EDGEWATER REDEVELOPMENT

SUBMITTAL PACKAGE
URBAN DESIGN COMMISSION

JANUARY 13, 2010

DESIGN EVOLUTION – INTEGRATION OF UDC COMMENTS

TRAFFIC AND CIRCULATION – VEHICULAR MOVEMENTS

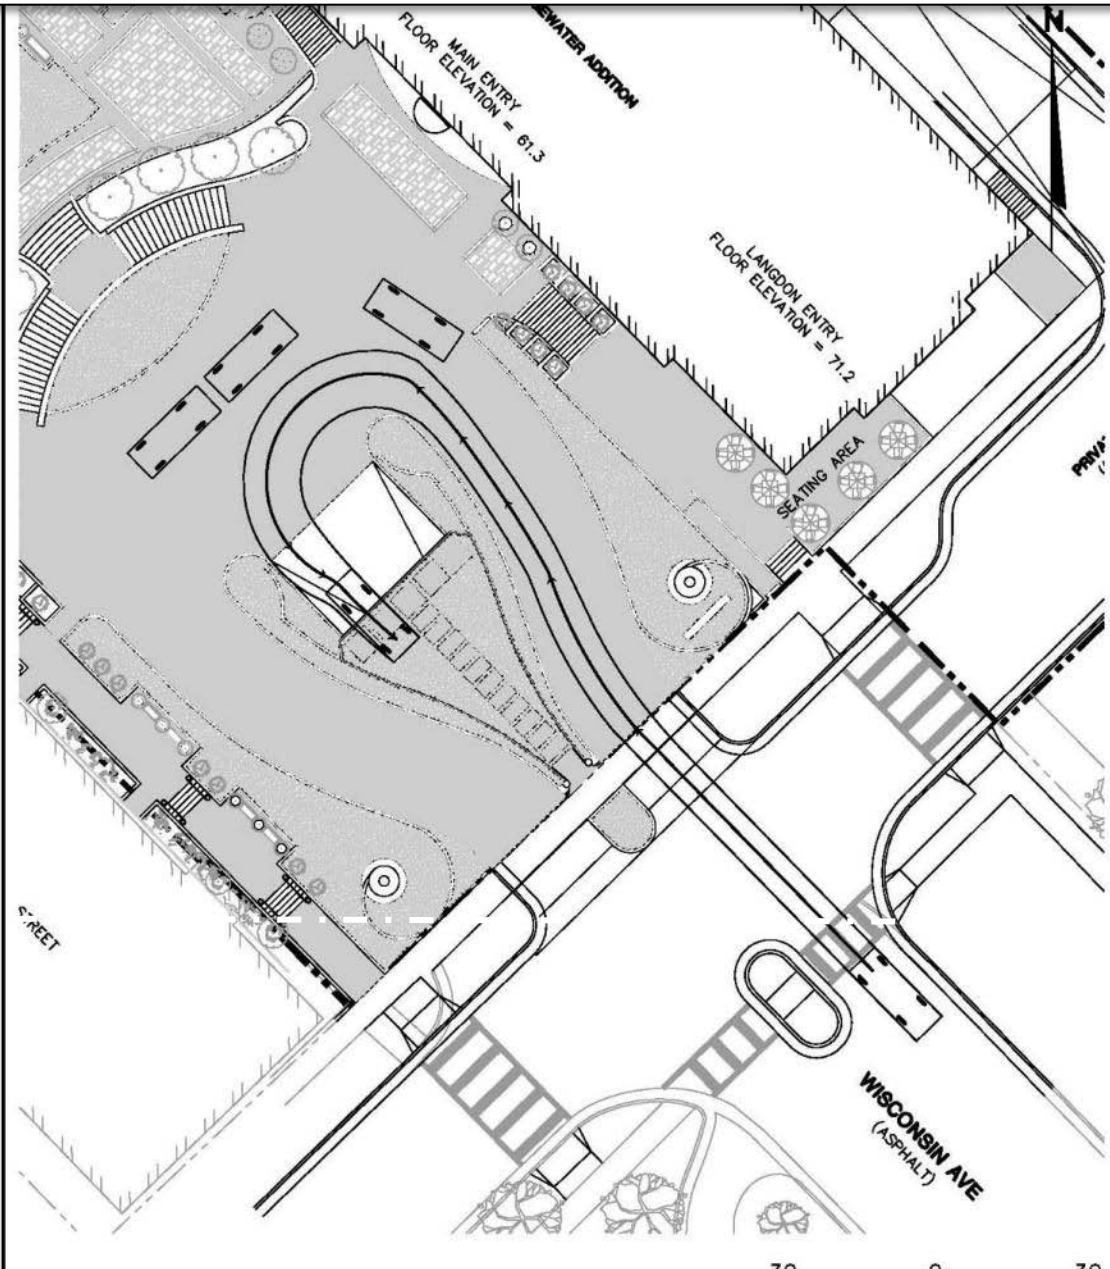
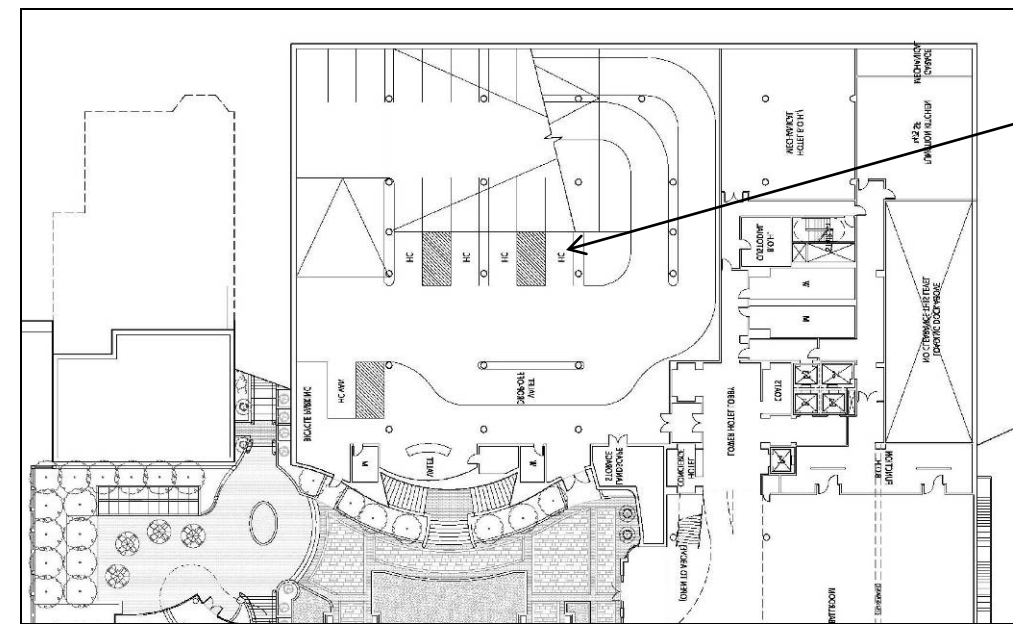
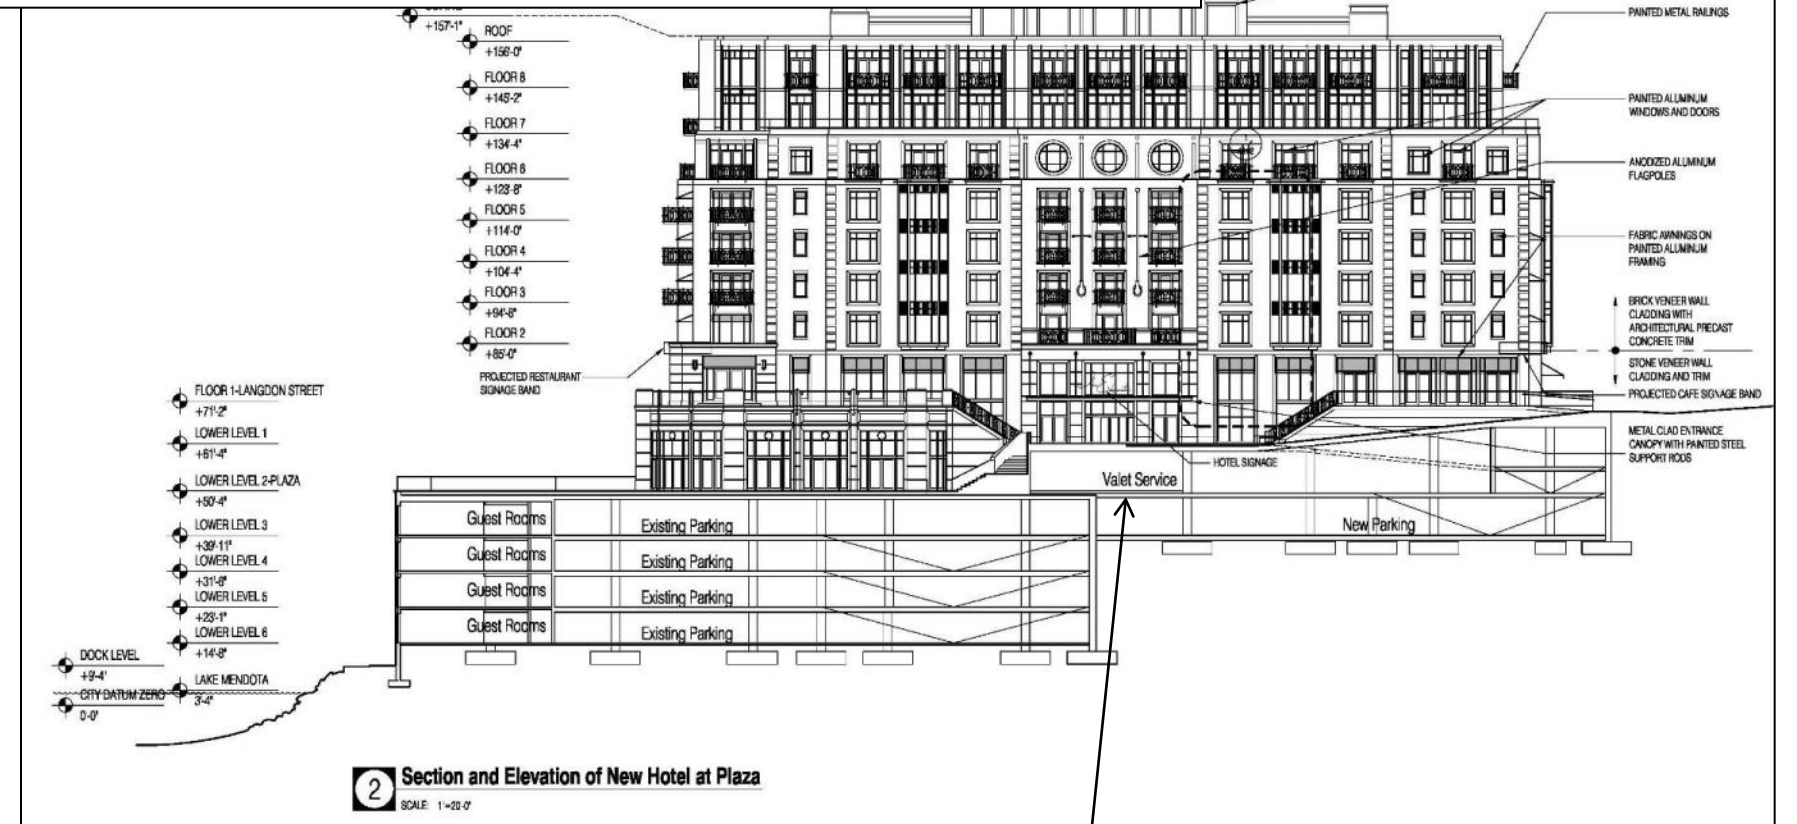
INFORMATION REQUEST: Describe vehicular movement on the site. Where do cars enter parking structure. Where is valet/drop off area.

The revised plan includes an internal valet and drop-off area to further mitigate traffic impacts in the view corridor, provide a direct drop-off for functions/events and provide an enhanced drop off for guests in inclement weather.

Drawing A1.12 – Roof of New Tower

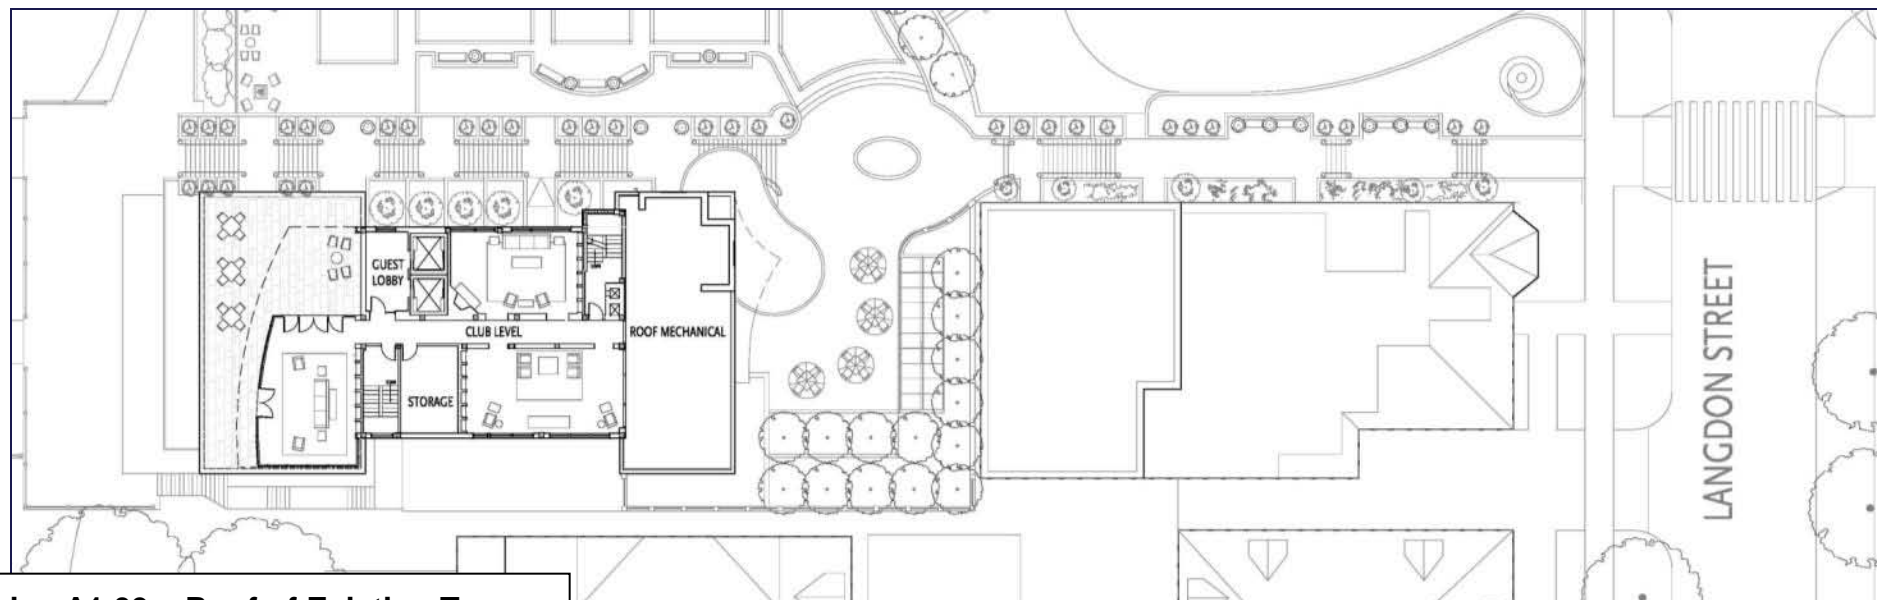
INFORMATION REQUEST – Clarify locations of roof-top installations

- Roof top mechanicals, cooling towers and elevator over-runs are enclosed /shielded by Penthouse;
- Secondary locations for roof-top installations are located adjacent to penthouse on new tower;

Elevation and Floor Plan- Levels 7 and 8

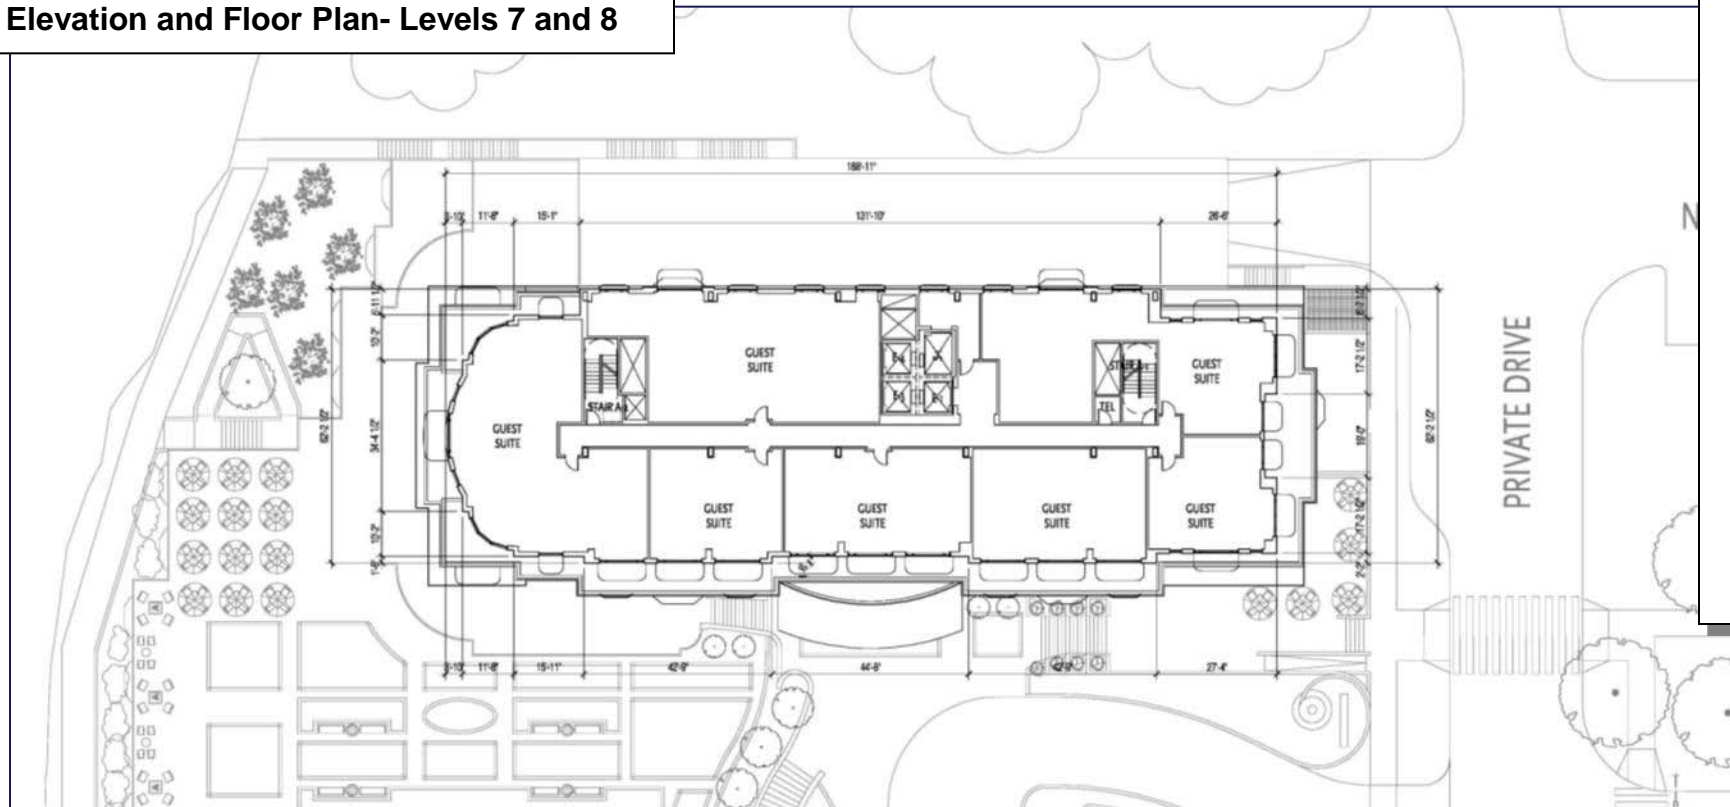
INFORMATION REQUEST – Provide detail on proposed residential units.
